# 101 W. ROY ST.

SDCI# 3036111-LU (3035904-EG)  
DESIGN REVIEW BOARD RECOMMENDATIONS  
TBD

# ADMINISTRATIVE EARLY DESIGN GUIDANCE - BUILDING MASSING

OPTION 3- **PREFERRED**

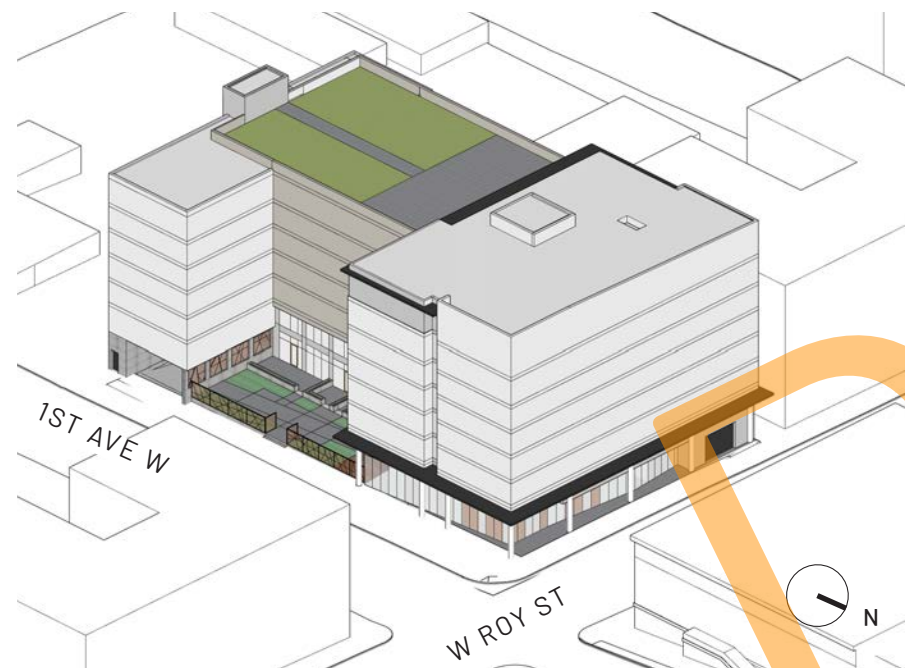
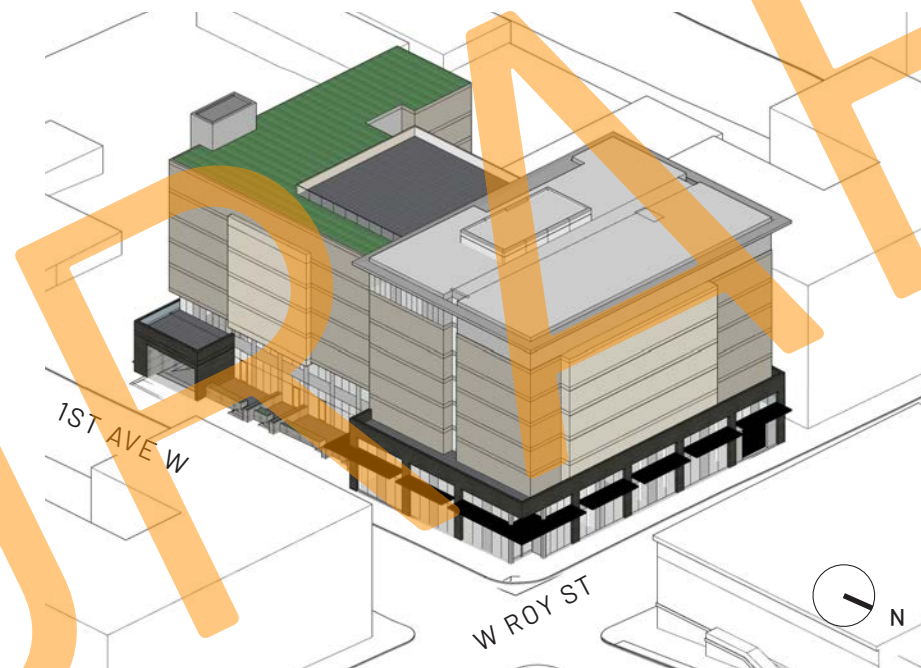
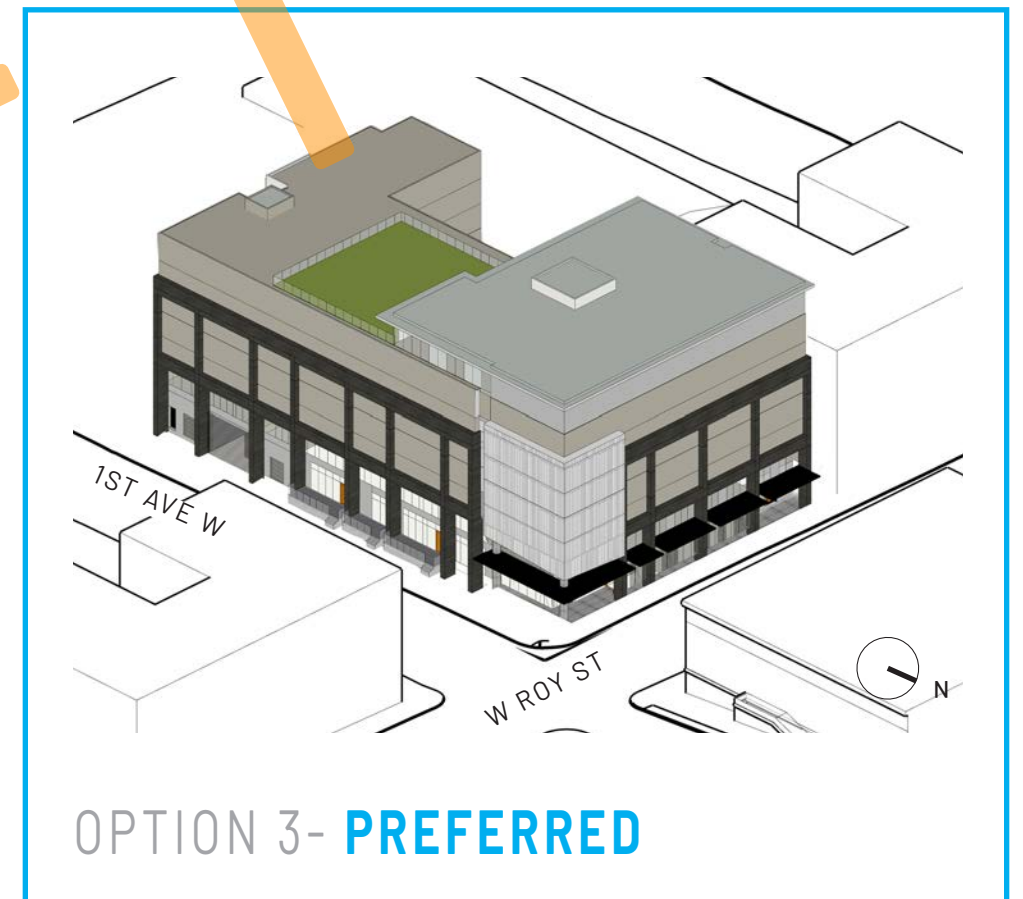
**ADR GUIDANCE:** The surrounding neighborhood has a strong context of simply shaped buildings clad in masonry. For this reason, staff agrees with public comment regarding context and agrees with the applicant that their preferred option best responds to the surrounding neighborhood and should be used to build future iterations of the proposal. (CS2-A, CS3-A-3, CS2-C-1, CS2-3-a, CS3-A-1, DC2-A-1, DC2-B-1)

The site has a unique location; positioned between two historic buildings (Chandler Hall and Del Roy) and adjacent to On the Boards theater across the street provides a great opportunity to “stitch” the existing historic fabric.

We have pursued the proffered option 3 and maintained the simple overall form. As a response to the neighborhood character, the brick is raised and occupies more of the building facade following and re-interpreting facade concepts found in surrounding buildings. The current design enhances the historic attributes that give the Uptown neighborhood a distinctive sense of place, referencing and respecting but using modern forms and materials mixed in..

# HISTORIC CONTEXT ANALYSIS - RESPONSE TO SURROUNDING FABRIC

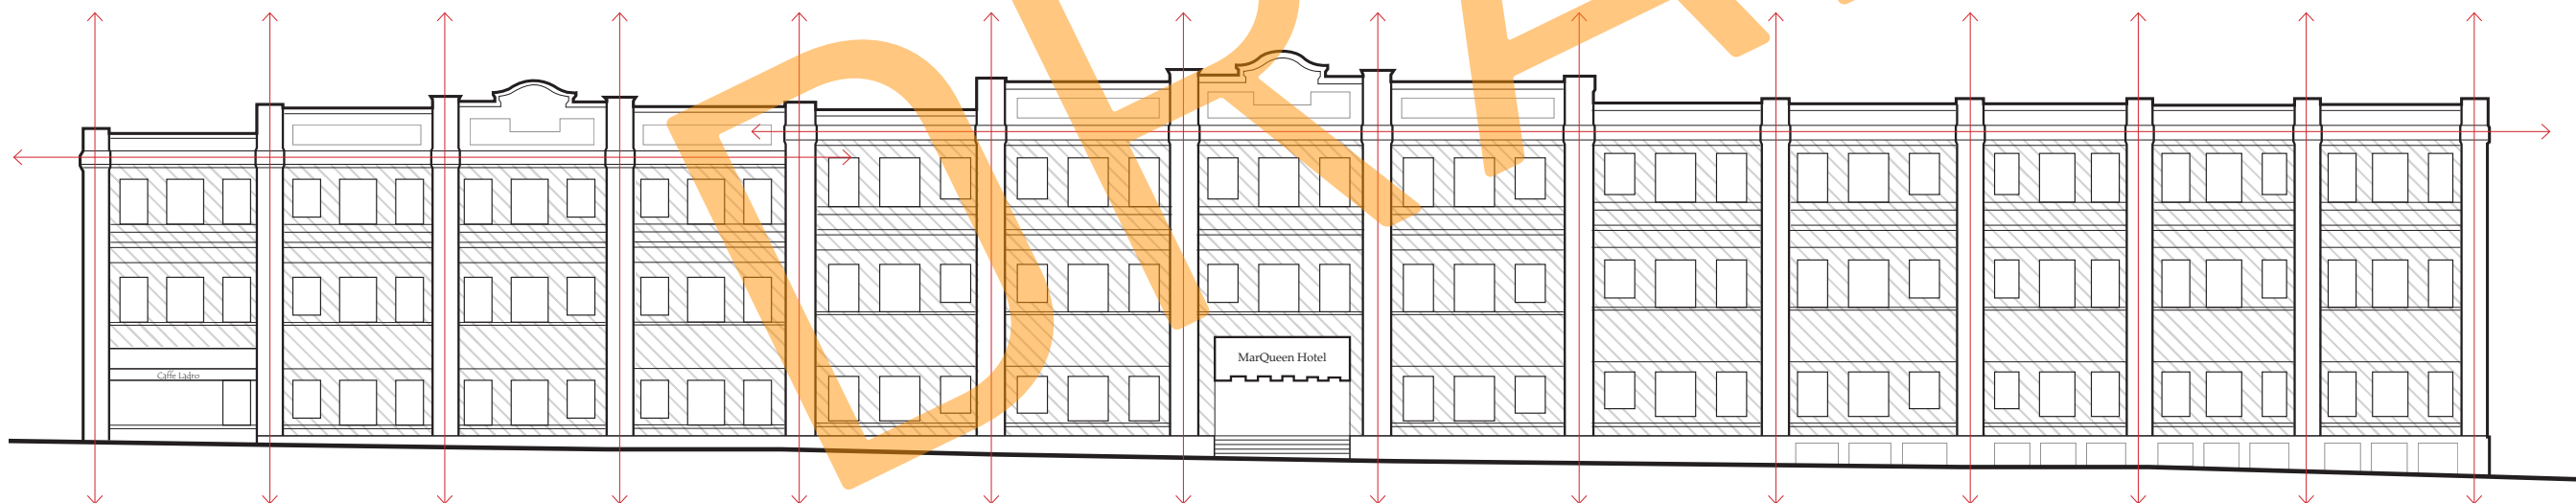
**ADR GUIDANCE:** *In agreement with public concerns about scale, staff notes that the proposed gridded frame feature is not in keeping with the surrounding context and is too large to use effectively as a scaling feature. Use masonry as a field material with deeply set windows as a scaling element. This will help respond to the many comments about the proposed building's size.*

The proposed design uses historic references such as arcade on the ground level, strong vertical pier expression, and the brick mixed with other materials to inform the secondary facade modulation. This results into a feeling of punched windows, but in layered facades like many of the masonry buildings around the site.

The overall building is broken into three main parts relating to different neighboring characters. The main corner (NE) is accented with an area of "masonry as a field with true punched windows". The other brick facades begin to break this down incorporating other materials, but keeping the facade organizations found in the historic brick buildings.

# BUILDING DESIGN - BUILDING SCALE AND SECONDARY MODULATION

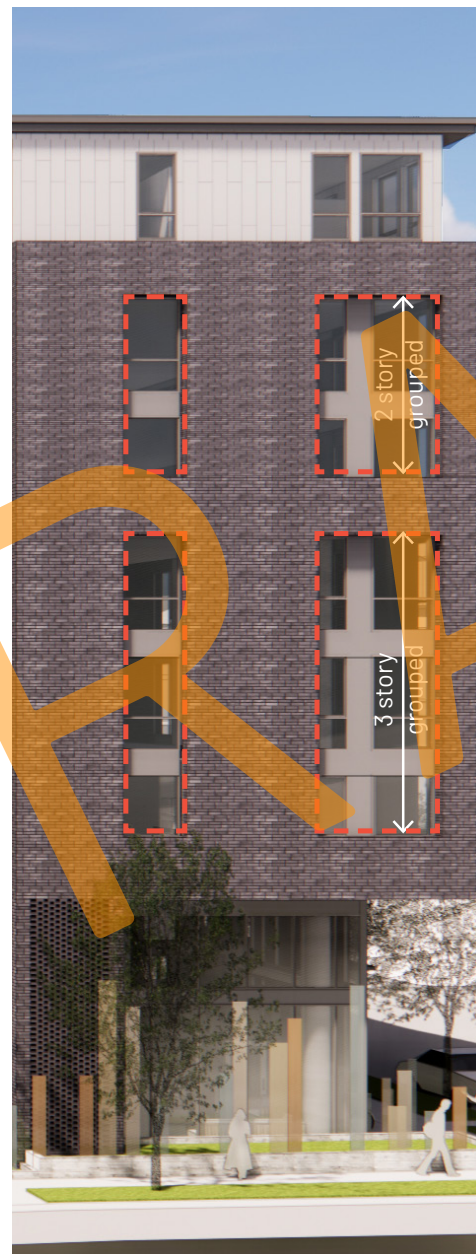
**ADR GUIDANCE:** Study the pattern of openings and rhythm of the surrounding context and use your findings to instruct the creation of window modules. Review the proposal for 3025946-EG page (16-27) for an example of a successful examination of facade features along Roy street. Provide a similar exploration at the Recommendation phase.  
**(CS3-A-1 CS3-A-3, DC2-A-2, DC2-B-1, DC2-C-1, DC2-D-2, DC2-3-b, DC4-A-1 and DC4-1-a)**

**RESPONSE:**  
 The project brick facades reflect surrounding historic facade patterns and concepts using a range of modern materials. The corner element keeps to the most simple punched windows deeply set in a plain field of brick, similar to On The Boards building. The north facade keeps the same colors but mixes in layering and uses some additional materials but keeping the deep set windows. The south portion of the East facade uses the same detailing and materials as the north but begins to reflect the modern apartment buildings found further south along 1st Ave W. The East elevation raises the brick up from the ground, removes the horizontal datum, and emphasizes the taller pillars with material color infills.

PROPOSED CORNER ENTRY

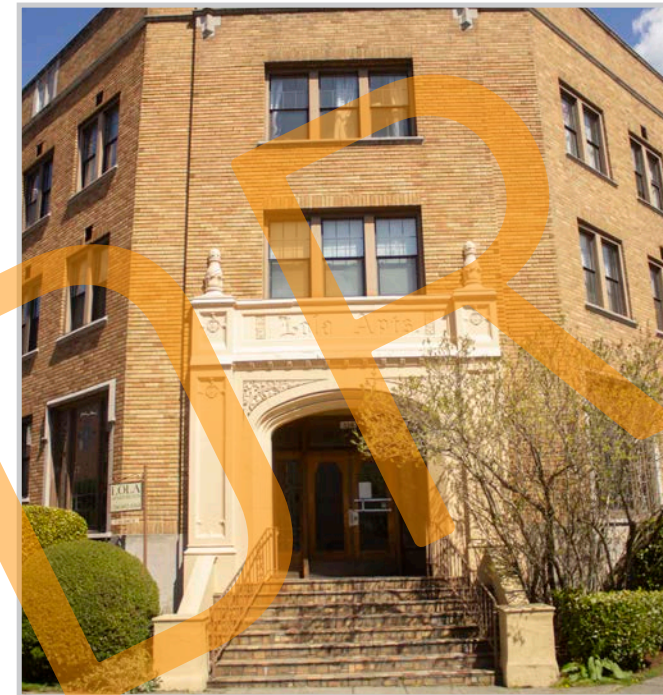
**ADR GUIDANCE:** The metal scrim feature is not in keeping with the context of the neighborhood. Explore more traditional ways of marking the corner that responds specifically to permanent architectural features of the buildings in the surrounding area. Respond to the Uptown Guidelines that request art in a way that does not overwhelm the art across the street. (CS3-A-1, CS2-C-1, CS3-1-b and DC4-1-c)

The metal scrim element at the NE corner is removed and replaced with field of masonry that completes the simple building massing, similar to surrounding buildings.

Corner conditions throughout the neighborhood are pictured here including entries at corners and recessed entries forming near porticoes or porches. The corner here serves as the entry “porch” with the actual door and small canopy off-center giving more prominence to the new at-grade art and the “stage” behind the art with it’s accent lighting and feature light fixture in the double height space.”

# BUILDING DESIGN - CORNER ARTICULATION / PUBLIC ART

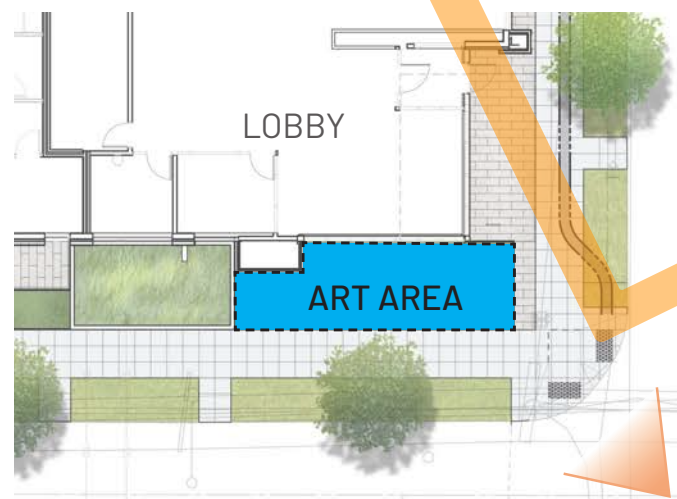
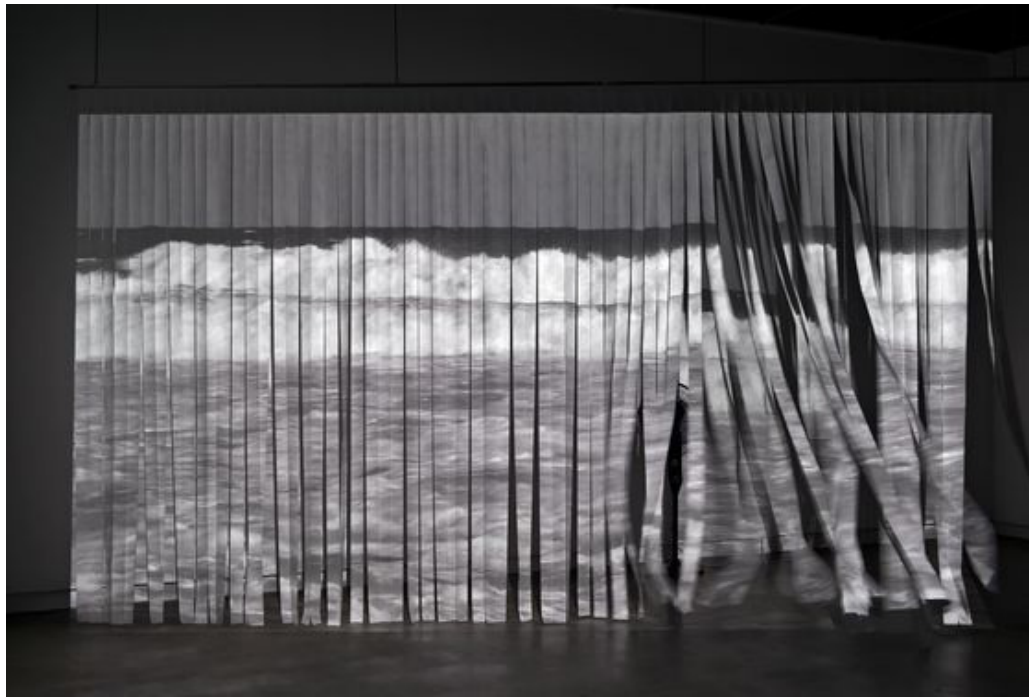
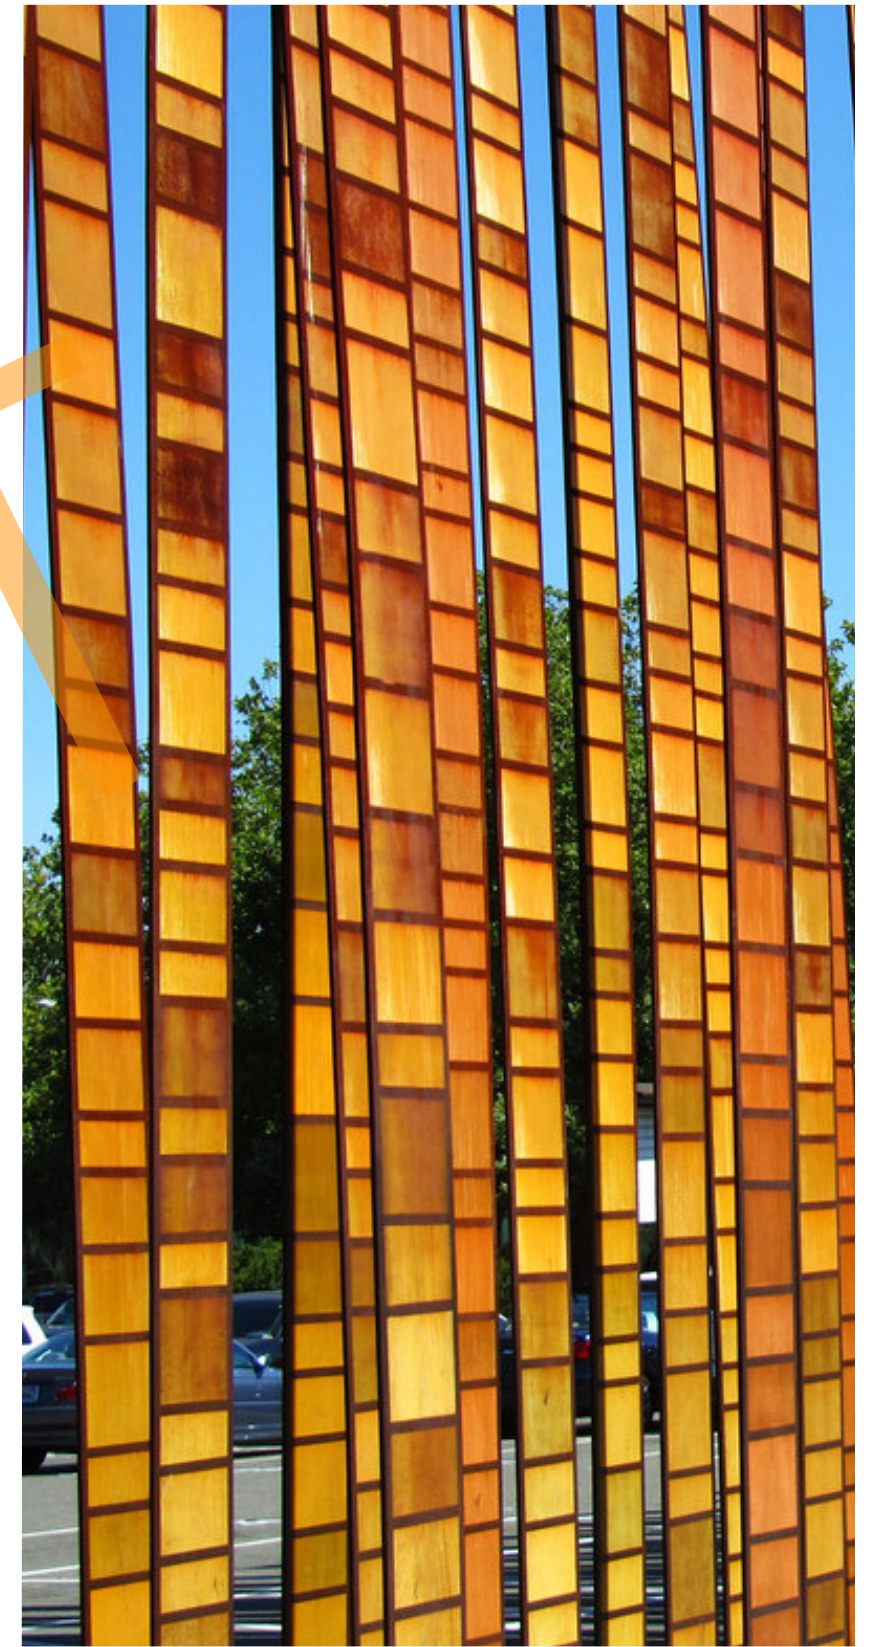
**ADR GUIDANCE:** *The metal scrim feature is not in keeping with the context of the neighborhood. Explore more traditional ways of marking the corner that responds specifically to permanent architectural features of the buildings in the surrounding area. Respond to the Uptown Guidelines that request art in a way that does not overwhelm the art across the street. (CS3-A-1, CS2-C-1, CS3-1-b and DC4-1-c)*

The public art sculptural feature is placed at the NE corner as a focal point marking the significant street intersection as well as relating to the entry of On the Boards theater across the street. The sculptural art and lighting is an integral part of the design concept, linking to theater district as well as the "Blades of Grass" sculpture at the opposite end of W. Roy Street in Uptown (at Seattle Center).

Inspired by the theater curtain, the art feature will incorporate 3D elements and lighting to create visual interest and become a way-finding element for the guests and residents of the neighborhood. The sculpture will give a sense of activity to an otherwise quiet corner.

Sculptural element and building will include artistic lighting accents to further enhance night time (theater district) experience. The lighting will wash vertical sculptural elements evoking a sense of movement.

RESIDENTIAL STOOPS ALONG 1ST AVE W

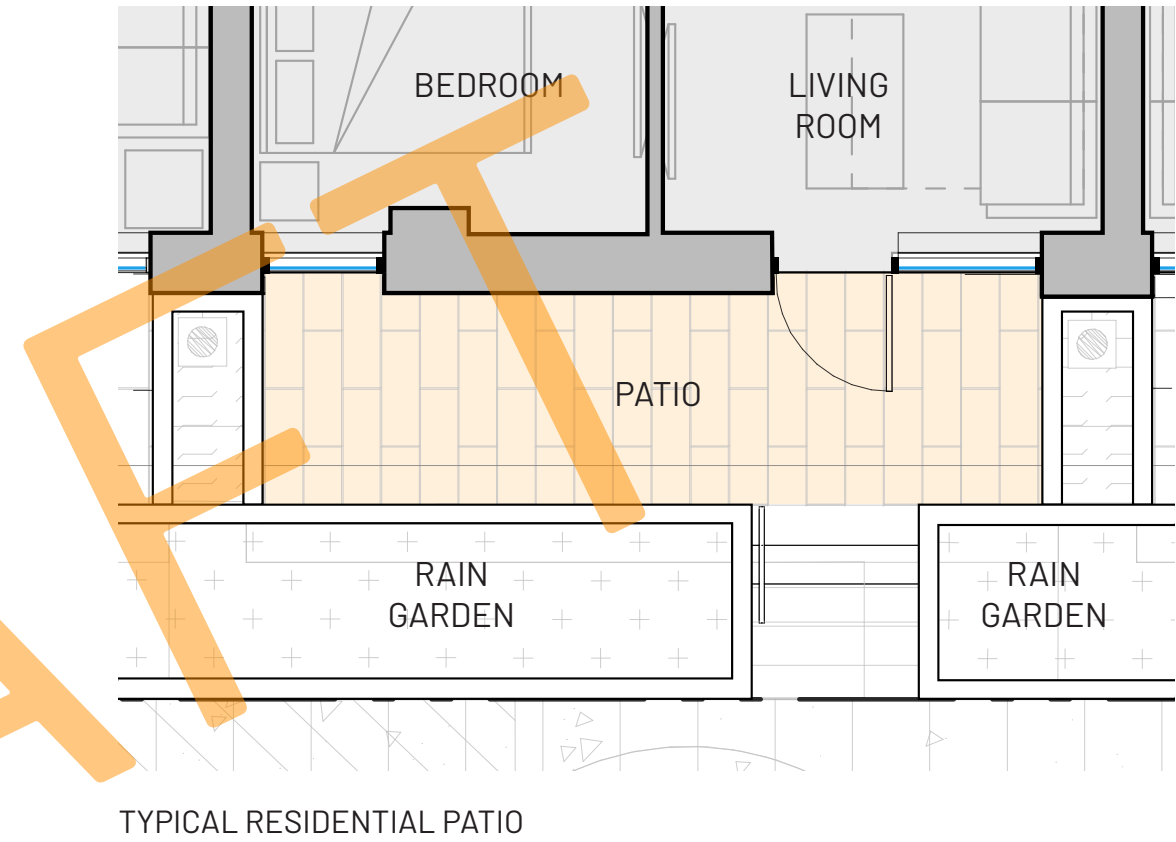
**2a** **ADR GUIDANCE:** Successful ground floor units include a buffer to create a semi-private weather protected, space with stoops wide enough for personalization. At Recommendation, show how this guidance is integrated into your proposal explain and why the units will not present as a blank wall of drawn curtains when completed and occupied. (PL2-B-1, PL3-B-2, PL3-A-3P, PL3-A-4 and PL3-3-a)

**RESPONSE:**  
The at-grade unit design incorporates landscape feature to create layers of separation from the public realm, creating appropriate buffer for the residents. The large unit patios are raised above the adjacent sidewalk to provide additional privacy.

# SITE PLAN - GROUND LEVEL DETAILS

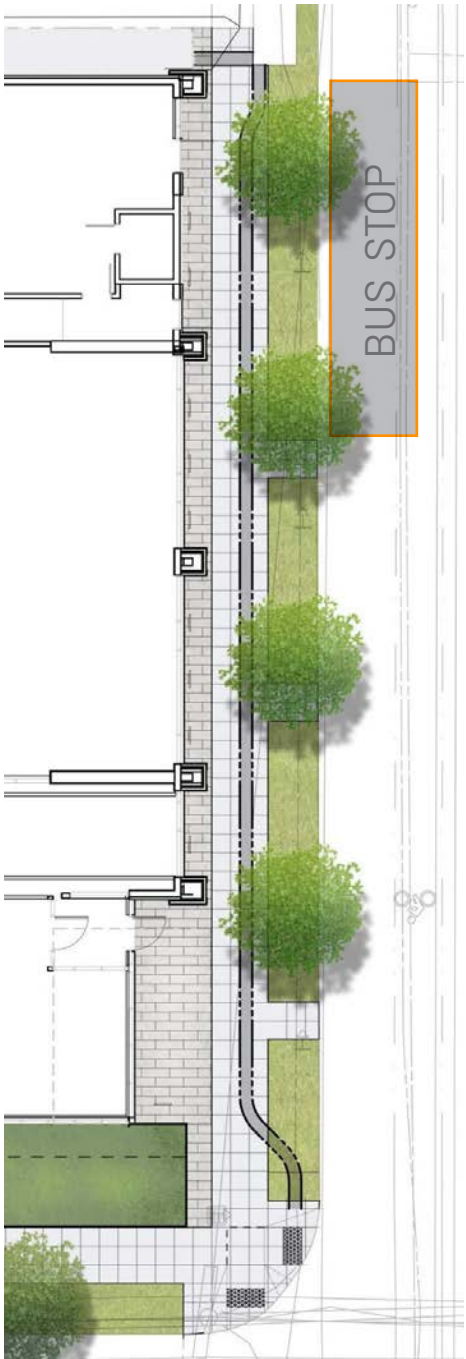
**2b** **ADR GUIDANCE:** *The frame element defining the ground floor units makes them look overly commercial. Explore ways to create fine-grained detail at the units. Use brick as a field material that comes all the way to the stoop level. (CS3-A-1 CS3-A-3, DC2-A-2, DC2-B-1, PL3-B-2, PL3-A-3P, PL3-A-4, PL3-3-a DC2-C-1, DC2-D-2, DC2-3-b, DC4-A-1 and DC4-1-a)*

The design of ground level units incorporate canopies for the overhead protection, stepped rain-gardens, and significant insets in the facade, indicating the unit entry points as well as creating secondary modulation of the first two stories of the building.

The siding material is textured and color "pop" is provided at reveal to storefront windows. The multi-level planting adds further interest and only simple stair handrails are provided rather than full guardrails and/or fences that would be too heavy-handed.
